ATTACHMENT I TO JPN-87-13

PROPOSED CHANGE TO THE TECHNICAL SPECIFICATIONS REGARDING
PRESSURE-TEMPERATURE LIMITS (PTS-86-05)

JAMES A. FITZPATRICK NUCLEAR POWER PLANT
DOCKET NO. 50-333
DPR-59

SAFETY EVALUATION FOR THE PROPOSED CHANGE TO THE
TECHNICAL SPECIFICATIONS REGARDING
PRESSURE-TEMPERATURE LIMITS (PTS-86-05)

FIGURE 3.6-1
REACTOR VESSEL PRESSURE - TEMPERATURE LIMITS

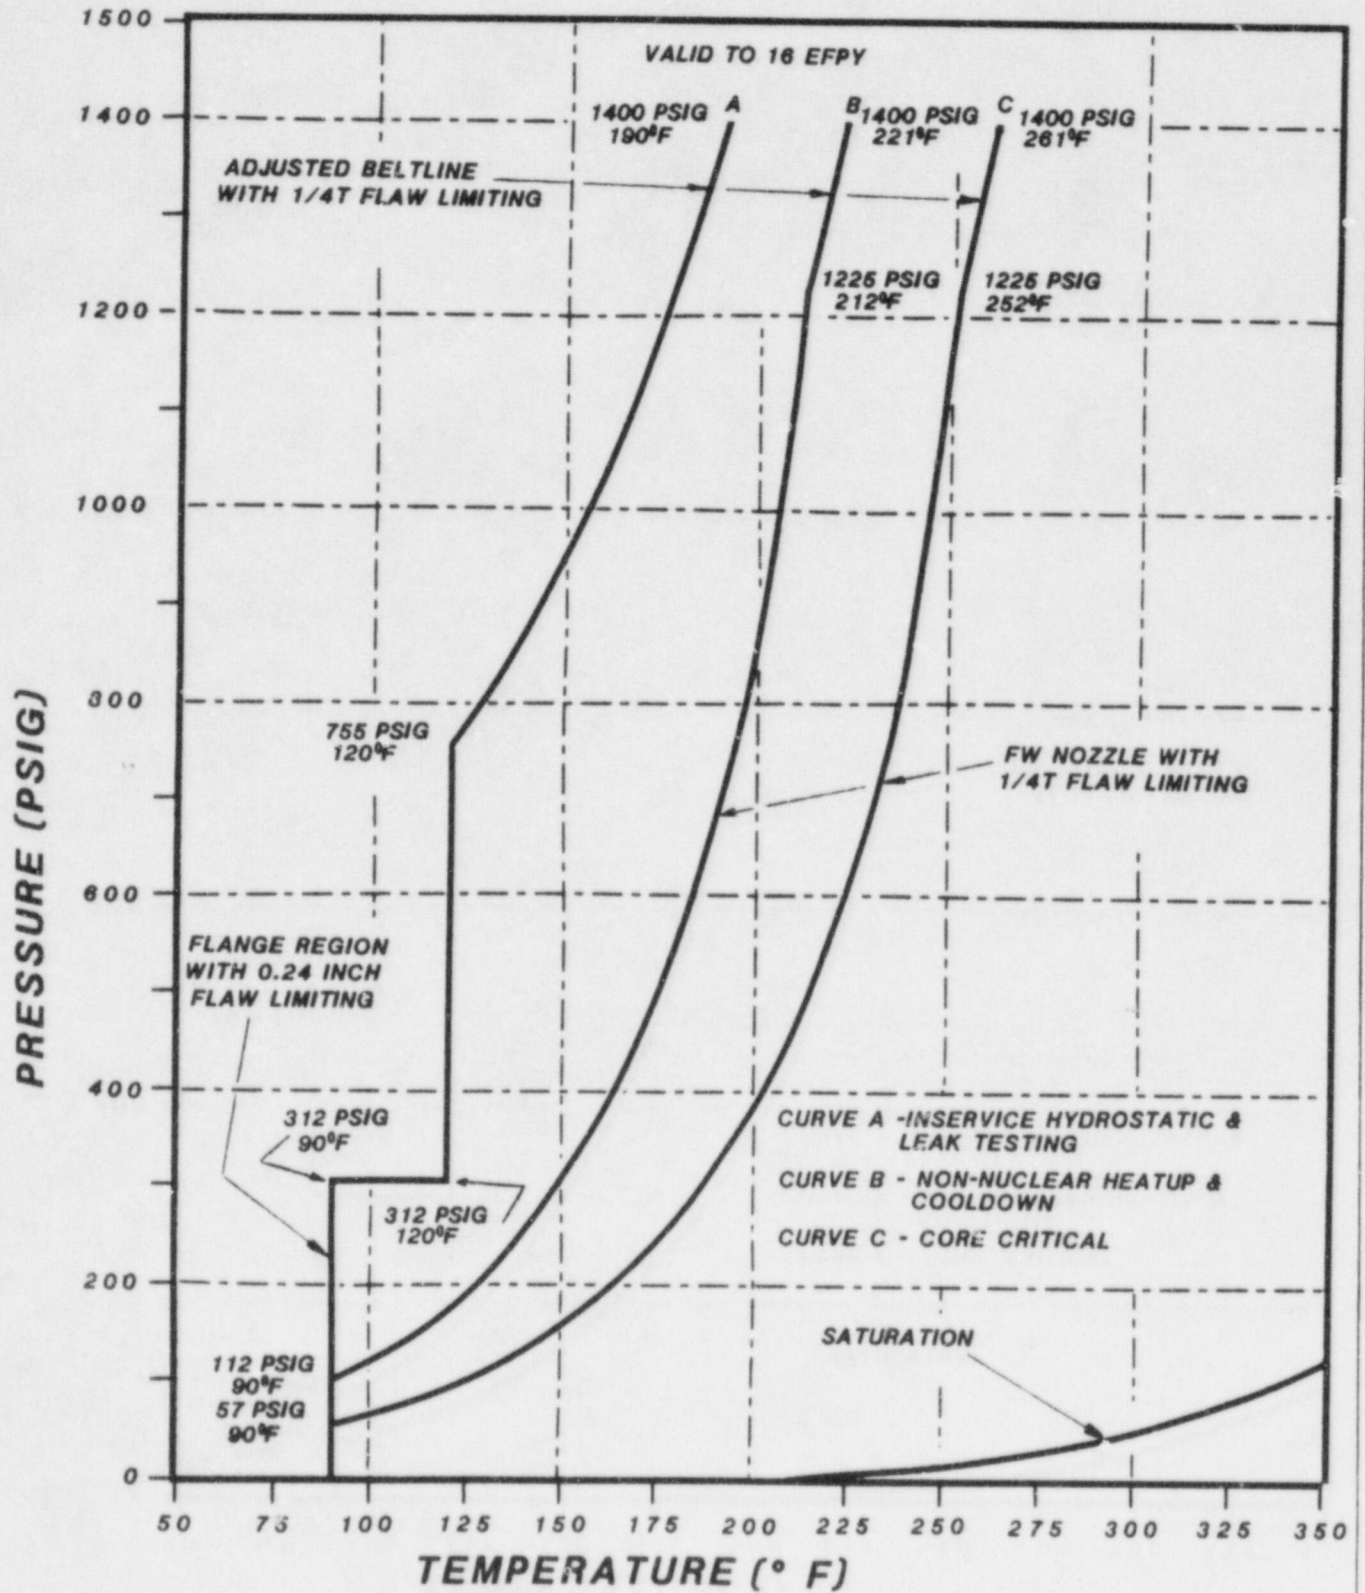
The first surveillance capsule containing test specimens was withdrawn in April, 1985 after 6 EFPY. The test specimens removed were tested according to ASTM E 185-82 and the results are in GE report MDE-49-0386. The curves of Figure 3.6-1, A through C, reflect findings in the report related to copper-phosphorus content of the reactor vessel shell beltline, flux wire testing fluence distribution analysis, and Charpy V-Notch specimen testing. The next surveillance capsule will be removed after 15 EFPYs of operation and the results of the examination used as a basis for revision of Figure 3.6-1 curves A, B and C for operation of the plant after 16 EFPYs.

146-148	3.6 and 4.6.B Bases	This section is deleted.
148	3.6 and 4.6.C Bases	Change, "Radiological Effluent Technical Specification Section 3.2a" to "Radiological Effluent Technical Specification 2.3.A."
163	Fig. 3.6-1	Replace with new figure, "Reactor Vessel Pressure-Temperature Limits."

In compliance with the requirements of 10 CFR 50 Appendix H, a surveillance specimen removed from the FitzPatrick reactor was evaluated. Based on this evaluation, new operating limit curves valid up to 16 effective full power years were developed. The proposed

During in-service hydrostatic or leak testing the Reactor Coolant System pressure and temperature shall be on or to the right of curve A shown in Figure 3.6-1 and the maximum temperature change during any one hour period shall be:

During heatup by non-nuclear means (mechanical), cooldown following nuclear shutdown and low power physics tests the Reactor Coolant System pressure and temperature shall be on or to the right of the curve B shown in Figure 3.6-1 and the maximum temperature change during any one hour shall be $\leq 100^{\circ}\text{F}$.

During all modes of operation with a critical core (except for low power physics tests) the reactor Coolant System pressure and temperature shall be at or to the right of the curve C shown in Figure 3.6-1 and the maximum temperature change during any one hour shall be $\leq 100^{\circ}\text{F}$.

Figure 3.6-1 curve A establishes the minimum temperature for hydrostatic and leak testing required by the ASME Boiler and Pressure Vessel Code, Section XI. Test pressures for in-service hydrostatic and leak testing are a function of the testing temperature and the component material. Accordingly, the maximum hydrostatic test pressure will be 1.1 times the operating pressure or about 1105 psig.

Figure 3.6-1, curve B, provides limitations for plant heatup and cooldown when the reactor is not critical or during low power physics tests. The thermal limitation is based on maximum heatup and cooldown rates of 100°F/hr in any one-hour period.

Figure 3.6-1, curve C, establishes operating limits when core is critical. These limits include a margin of 40°F as required by 10 CFR 50 Appendix G.
